CREEKLINE/I-10 SUBDIVISION

APPLICATION NUMBER 3 DATE November 2, 2017

REQUEST Subdivision

DETAIL SITE PLAN

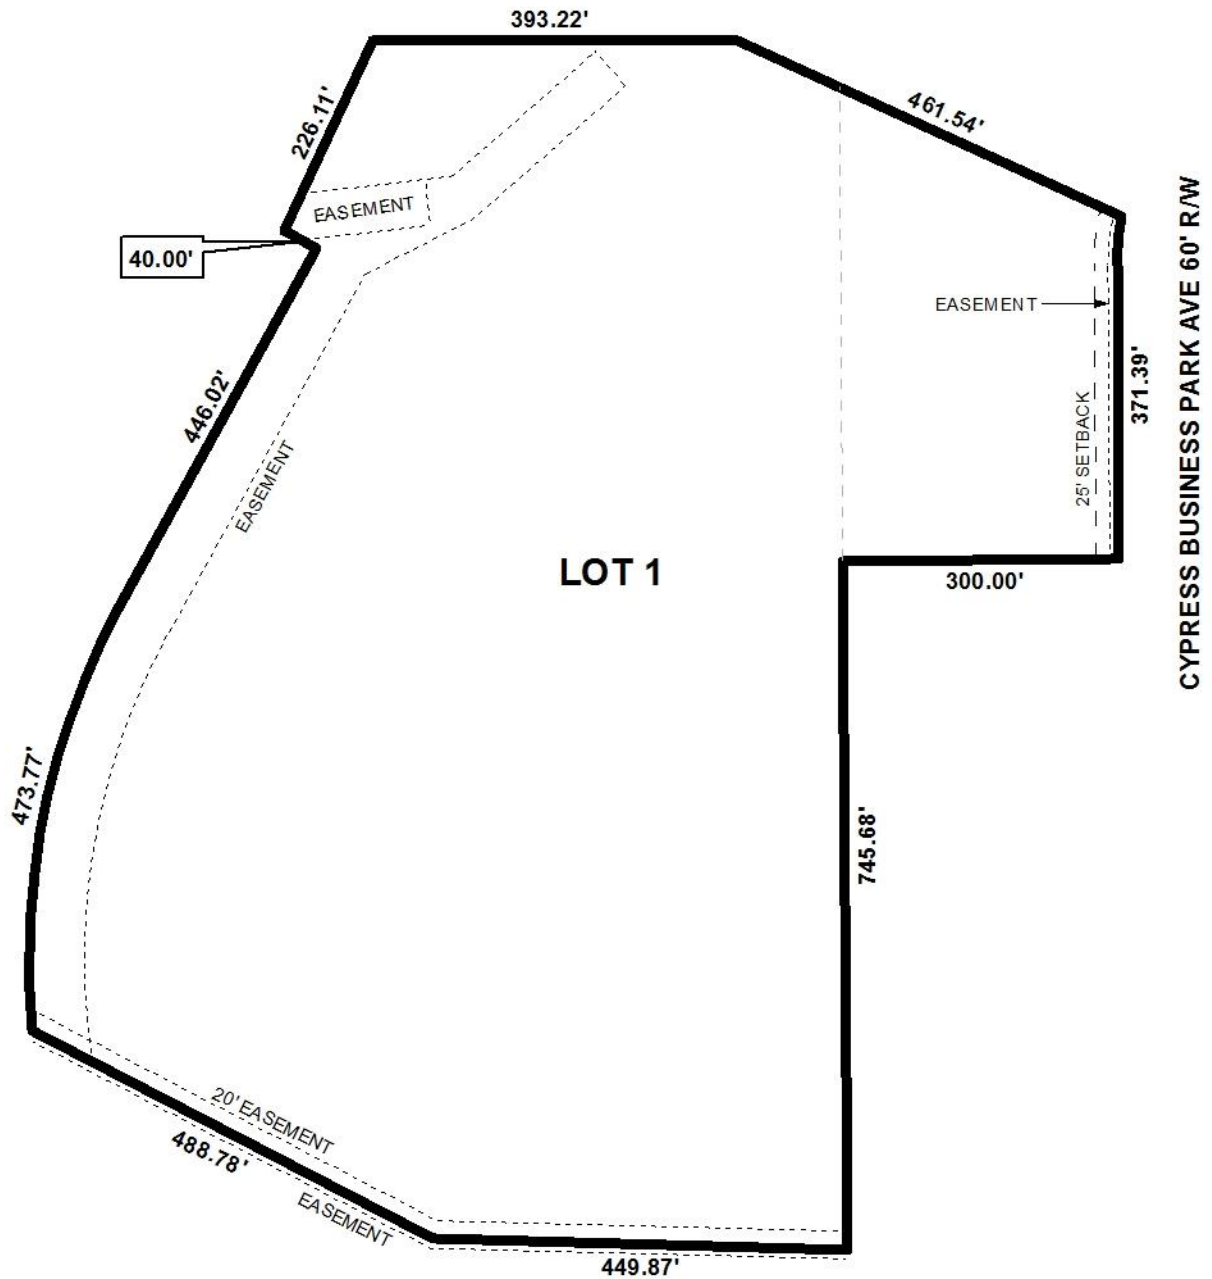
The proposed lot has frontage on Cypress Business Park Drive, a portion of which appears to be a public minor street with curb and gutter requiring a 50' right-of-way; and, on U.S. Interstate 10, an ALDOT-maintained limited access route requiring a 350' right-of-way. The preliminary plat illustrates sufficient right-of-way along Cypress Business Park Drive, but indicates a varying right-of-way along U.S. Interstate 10. The minimum existing right-of-way width for U.S. Interstate 10 should be depicted on the Final Plat. Once corrected, right-of-way information should be retained on the Final Plat, if approved; or, provision of a table on the Final Plat providing the same information may suffice.

The site is irregularly shaped and the width of the portion of the lot along Cypress Business Park Drive is large enough to be potentially re-subdivided, thus contributing to a width-to-depth ratio greater than 3.5 at the lot's potential building setback(s). Such lot designs are generally discouraged under Sections V.D.1. and V.D.3. of the Subdivision Regulations, respectively, the exceptions being the approval of lots located where varied and irregularly-shaped lot designs are common, and the informality of design is consistent with other lots in the vicinity. Previous subdivision approvals in the immediate vicinity affect the design of the proposed lot in such a way to perhaps satisfy the aforementioned conditions; however, waivers of Sections V.D.1. and V.D.3. will be required.

The 25' minimum building setback line is illustrated along Cypress Business Park Drive, but not along U.S. Interstate 10. As such, if approved, revision of the plat to illustrate the 25' minimum building setback line along all street frontages should be required.

Regarding access management it should be noted that, as a limited access route, access to U.S. Interstate 10 is only permitted by interchanges, and only at principle points. Such conditions are not compatible with the site; therefore, access to I-10 should be denied in favor of limiting access to Cypress Business Park Drive with a note on the Final Plat stating the site is limited to two (2) curb cuts with any changes in their sizes, locations or designs to be approved by Traffic Engineering, and conform to AASHTO standards.

Multiple easements are illustrated on the preliminary plat, including: 50'± drainage easements to the Northwest and West along U.S. Interstate 10; a 10' water line easement to the East along Cypress Business Park Drive; and, a 20' sanitary sewer or water line easement along the South

property line. If approved, a note should be required on the Final Plat stating no structures shall be constructed in any easement.

A portion of the site abuts an R-1, Single-Family Residential District, to the Northeast. As such, and per Section 64-4.D.1. of the Zoning Ordinance, an appropriate buffer in the form of a wall, wooden privacy fence, or the inclusion of a screen planting strip will be required at the time of development.

Finally, another portion of the site appears to be located in the flood zone as depicted on FEMA maps, and thus may be subject to flooding. The presence of floodplains indicate that the area may also be environmentally sensitive; therefore, the approval of all applicable federal, state and local agencies would be required prior to the issuance of any permits or land disturbance activities.

- 1) revision of the plat to depict the minimum right-of-way widths for U.S. Interstate 10 and Cypress Business Park Drive, or provision of a table on the Final Plat providing the same information;

- 2) retention of the lot size in both square feet and acres, or the provision of a table providing the same information;
- 3) revision of the plat to illustrate the 25' minimum building setback line along all frontages;

- 4) placement of a note on the Final Plat stating the lot is denied access to U.S. Interstate 10 and limited to two curb cuts to Cypress Business Park Drive, with any changes in their sizes, locations or designs to be approved by Traffic Engineering and conform to AASHTO standards;
